# UNITED STATES PATENT AND TRADEMARK OFFICE

<b>Office Action Summary</b>	<b>Application No.</b>	<b>Applicant(s)</b>	
	10/706,726	STREUER, PETER	
	<b>Examiner</b>	<b>Art Unit</b>	
	Ben Lewis	1795

## **DETAILED ACTION**

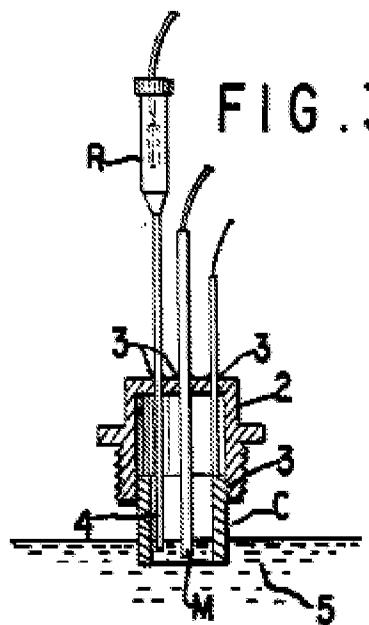
With respect to claims 13-17, 21, 23, 24, 25, 26, 30, 32, 35 Krabatsch et al. discloses a plug for an accumulator “battery”. The plug has degassing openings **9** and **19** and **18** (See Figure).

Krabatsch et al. teach an upper part **21** with opening **18** to the outside and a lower part **7** (See Figure). Opening **18** is also connected to the splash basket **7** (See Figure).

Krabatsch et al. teaches an acid cage **7** “splash basket” having an inner diameter that increases from the free end to the upper end of the acid cage and slots continuing as far as the free end of the splash basket (See Figure) (See page 2 line 1-10).

With respect to the shape of the slots, Krabatsch et al. do not specifically teach wherein each of the slots has a width that broadens with increasing distance from the free end of the splash basket. Unless applicant shows criticality for the claimed features, changes in size and shape is obvious absent a showing of unexpected results.

It is noted that applicant’s slot widths and basket shape appear to be similar to, if not identical to that shown in the Figure in DE 3330823.

With respect to slots including a free end extending toward the free end of the splash basket, Krabatsch et al. teach that feature **10** of the plug is an opening.

Since, there is no showing of unexpected results or showing of criticality of the end of Applicant's slots being free as claimed by the Applicant as opposed to the slots of Krabatsch et al. having lower edge support **24** at the end of the slots of Krabatsch et al., the plug of Applicant is obvious variant of the plug of Krabatsch et al.

With respect to allowing the splash basket to flex upon insertion into the openings of the degassing system, Krabatsch et al. discloses having lower edge support **24** at the end of the slots of Krabatsch et al., the plug of Applicant is obvious variant of the plug of Krabatsch et al. Examiner also notes that without the oring 24 of Krabatsch et al. being present would save material costs in the plug of Krabatsch et al. Examiner notes that oring 24 is a flexible material that would allow the splash basket of Krabatsch et al. to flex upon insertion into the openings of the degassing system of Krabatsch et al.

With respect to claim 22, Krabatsch et al. teach that annular grooves **4** and **6** are indented, into which O-rings **5** are inserted, in order to seal part **21** with the inner wall of the cover **1** (See Figure) ( See Page 2 lines 8).
